ATTACHMENT 5

REVISION H
ITS CHAPTER 5.0

SUMMARY OF CHANGES TO ITS CHAPTER 5.0

5.3 Unit Staff Qualifications

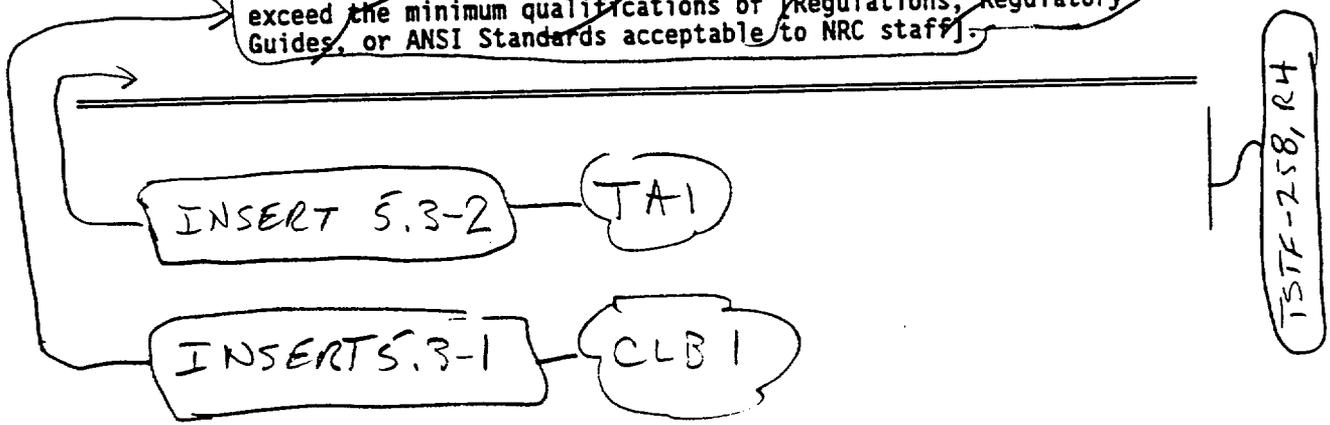
X1 The bracketed "Reviewer's Note" has been deleted. This information is for the NRC reviewer to understand exactly what is needed to meet this requirement. This is not meant to be retained in the final version of the plant specific information.
